Access Compliance Report Public Rights-of-Way (Curb Ramps)

Main Street: DORRANCE_DR Cross Street: N/A Location: N

ADA ID: RPRK211202121029 Ramp Type: Type 4 - Parallel Initial Pass/Fail: Pass Overall Compliance: No Severity Score: 25

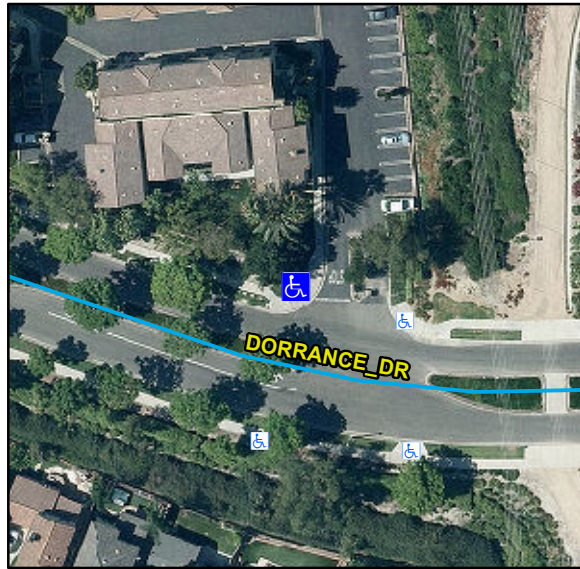
Compliance	Description	Data	Compliance	Description	Data
N/A	Ramp Length LT (in)	93	N/A	Ramp Length RT (in)	134
Yes	Ramp Width LT (in)	90	Yes	Ramp Width RT (in)	90
Yes	Ramp Run Slope LT (%)	4.5	Yes	Ramp Run Slope RT (%)	8.2
Yes	Ramp Cross Slope LT (%)	0.1	Yes	Ramp Cross Slope RT (%)	1.8
N/A	Landing Present	No	No	DWS Provided	No
N/A	Landing Length (in)	N/A	N/A	DWS Contrast	N/A
No	Landing Width (in)	N/A	N/A	DWS Length (in)	N/A
No	Landing Run Slope (%)	N/A	N/A	DWS Full Width	N/A
No	Landing Cross Slope (%)	N/A		DWS Offset Type	N/A
N/A	Landing Movement Obstructed?	No	N/A	DWS Offset Left (in)	N/A
	Landing Movement Type	Curb	N/A	DWS Offset Right (in)	N/A
N/A	Landing Shared	N/A			
N/A	Clear Space	Yes			
N/A	Clear Space To Crosswalk (in)	48			
N/A	Marked Crosswalk 1	No	N/A	Marked Crosswalk 2	No
	Crossing 1 Direction	S		Crossing 2 Direction	E
N/A	Marked Crosswalk 1 Width (in)	N/A		Marked Crosswalk 2 Width (in)	N/A
N/A	Ramp Inside Crosswalk 1	N/A	N/A	Ramp Inside Crosswalk 2	N/A

Crossing 1 Slope (%)	3.5		Crossing 2 Slope (%)	5.1
	Crossing 1 Cross Slope (%)	5.1		Crossing 2 Cross Slope (%)	1
Yes	Gutter Ponding	No	Yes	Curb Slope	3.8
Yes	Gutter Lip Height (in)	0		Road Run Slope (%)	1.5
No	Gutter Run Slope (%)	8.1		Road Cross Slope (%)	1.4
Yes	Gutter Cross Slope (%)	1.2	No	Perpendicular Joint Present	No
Yes	Overall Surface Condition	Acceptable			
	Cross Gutter Present?	No		Spandrel Present?	No
	Replace Cross Gutter?	N/A		Replace Spandrel?	N/A

Remove & Replace Curb Ramp With Two New Directional Ramps or Equivalent. Remove & Replace Gutter.
